RE: Data Responses from Peasha, Set 1
Cosumnes Power Plant (01-AFC-19)

COSUMNES POWER PLANT (01-AFC-19)

DATA RESPONSE, KATHY PEASHA SET 1

Figure NO-1
L90 Noise Levels at CPP Site (1) and Residence on Kirkwood (2)
April 3, 2002

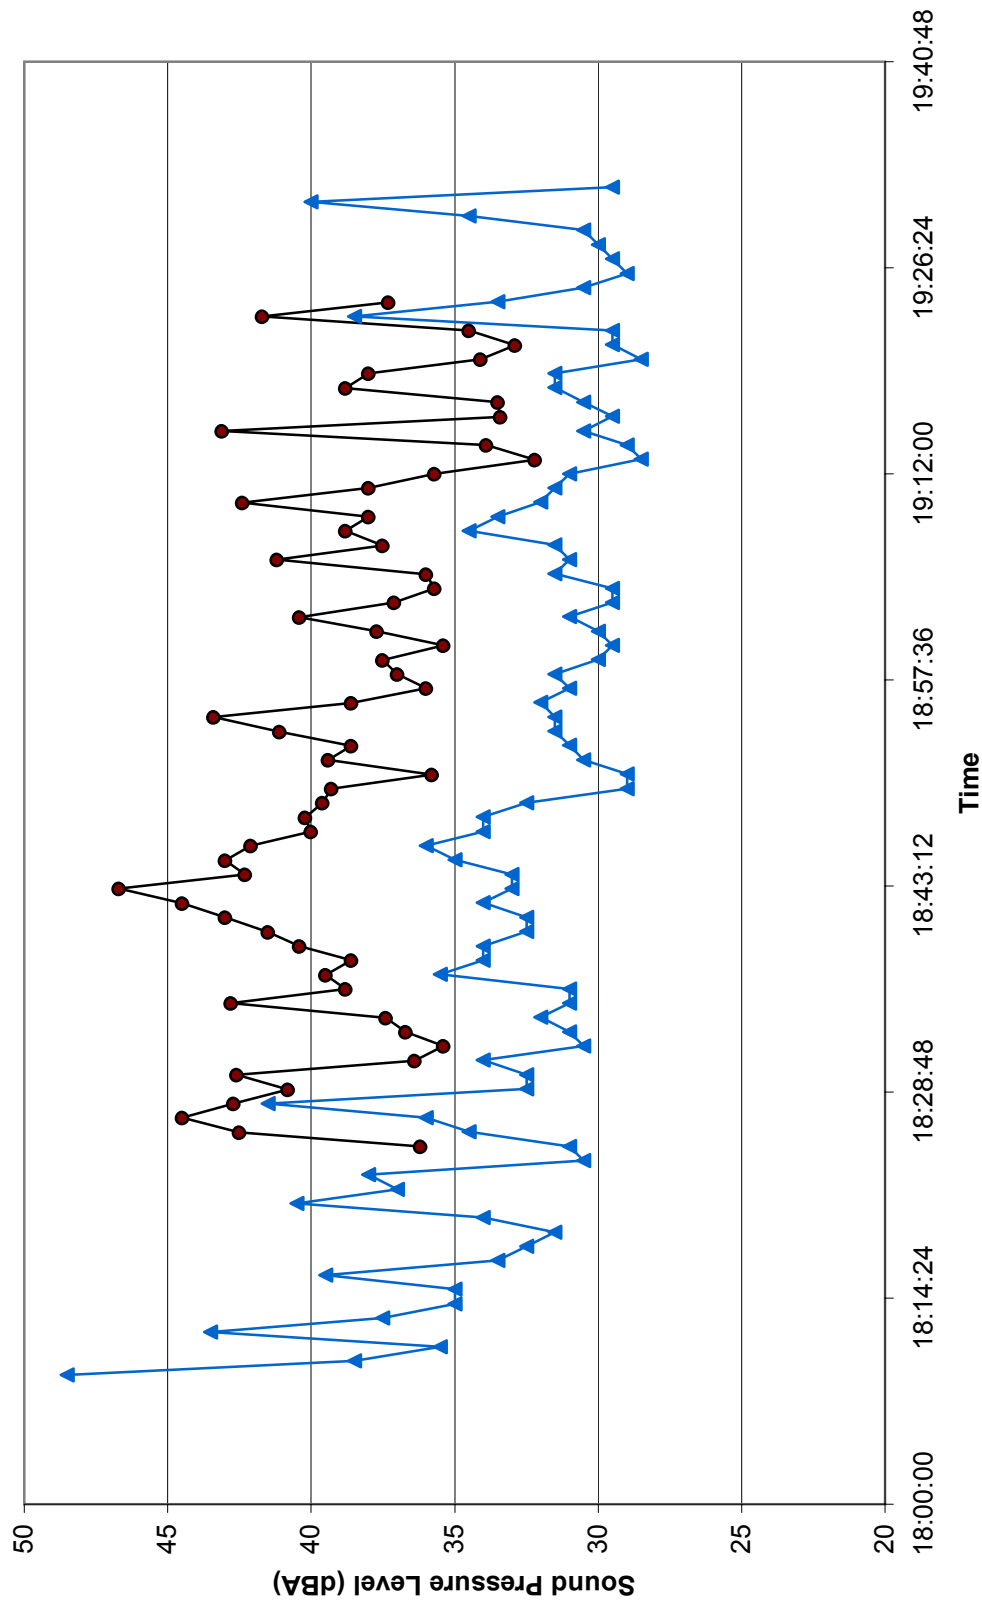
NO-1. Please provide additional noise surveys at my residence with my knowledge of when actual survey will be conducted. My residence is referred to in AFC 8.5 as R-2 (5,100 feet) 11615 Kirkwood Street.

NO-2. Every effort should be made to ensure that the additional noise survey is not done at a time when adjacent vineyard operators are carrying out their unusual and/or seasonal nighttime operations.

Response: Based on your verbal request, additional monitoring was conducted during the evening hours of April 3, 2002, when one would expect nighttime activities would be taking place. Measurements were taken concurrently at M1 (location used in the AFC) and on the opposite side of Kirkwood Street from your home (11615 Kirkwood Street). The results are presented in Figure NO-1 attached. The L90 noise levels measured at your home consistently exceeded those recorded at the site.

The CEC had a similar concern. CEC Data Request #65 states: "... please address the question of whether the noise level data collected at site M1 reasonably represent the noise exposure at the residences affected." The results of Figure NO-1 clearly show that the ambient noise monitoring performed at M1 is conservative in that the L90 at Kirkwood (i.e., the area of the affected residences) is consistently higher than the L90 at M1.

Response: No agricultural activities were observed during the monitoring period.
